TOWN OF CUMBERLAND PLANNING BOARD MEETING MINUTES Tuesday, May 17, 2022

- **1.** The applicant shall provide a copy of the Maine DEP SLODA permit prior to the issuance of first building permit.
- **2. Sketch Plan Review** of a proposed seven (7) lot subdivision, located on Tuttle Rd., Tax Assessor Map U11, Lot 4A in the Town Center District (TCD) / Setback Overlay 2 (S2) Zone. *Applicant/Owner: William Wyatt. Representative: David Latham, P.E. Trillium Engineering Group.*

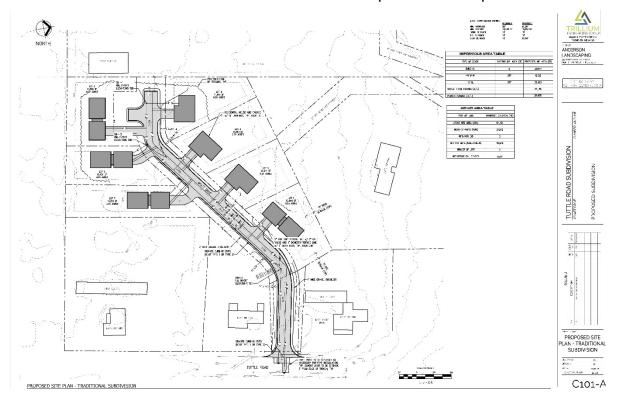
Mr. Auclair noted that he read the Town Attorneys' message and asked if it has occurred before where a buffering waiver was given for the reason of creating a hardship. Ms. Nixon said she does not recall that this has been done for that specific reason.

Chairman Record noted the Town Attorney's comment was that the Planning Board may waive a standard if it finds either an unnecessary hardship will result from strict compliance with the subdivision standards or there are special circumstances of a particular plan that makes the standard inapplicable.

Eric Dube, P.E., Trillium Engineering Group, explained that there are three subdivision proposals. A traditional design with a 75 foot perimeter butter, a seven lot traditional design without a perimeter buffer and a five lot clustered subdivision design without a perimeter butter. Mr. Dube described the location of the proposed subdivision and the abutting properties.

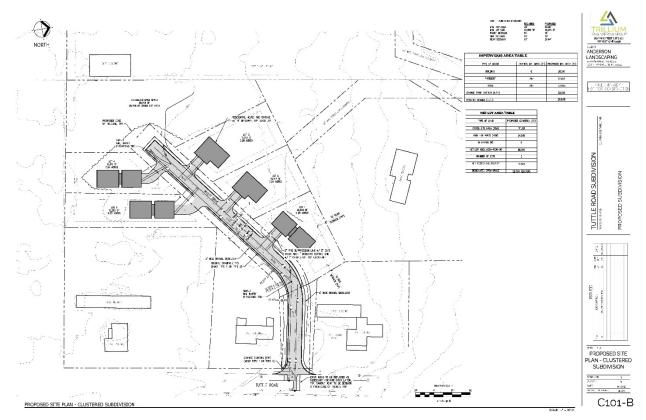
Mr. Dube outlined a seven lot traditional subdivision plan without a perimeter buffer.

Mr. Auclair asked about setbacks and Mr. Dube explained that the setbacks meet the requirements for the underlying zone.

Mr. Dube answered questions from the Board. Board members expressed concerns with the lack of a perimeter buffer.

Mr. Record expressed preference for a cluster style subdivision. Mr. Record said that in this instance, a 75 foot buffer may not be reasonable but he is not a fan of going down to 15 feet and would like to see a 40 or 50 foot buffer. Mr. Record said that he does not believe that requiring a buffer would be a hardship and even one house on this lot would make a fair amount of money.

Mr. Auclair agreed that smaller lots in this location are fine and said the buffer is important. Mr. Auclair referred to development on Wyman Way and said people buying homes there know what the spacing is between the homes and know what they are getting. Mr. Auclair said that if the buffer could work, especially with the residential places, he could live with a traditional subdivision.

There was no need for a motion to table. The applicant was asked to revise the plans to show a reduced buffer as desired and return to the Board at a later date.
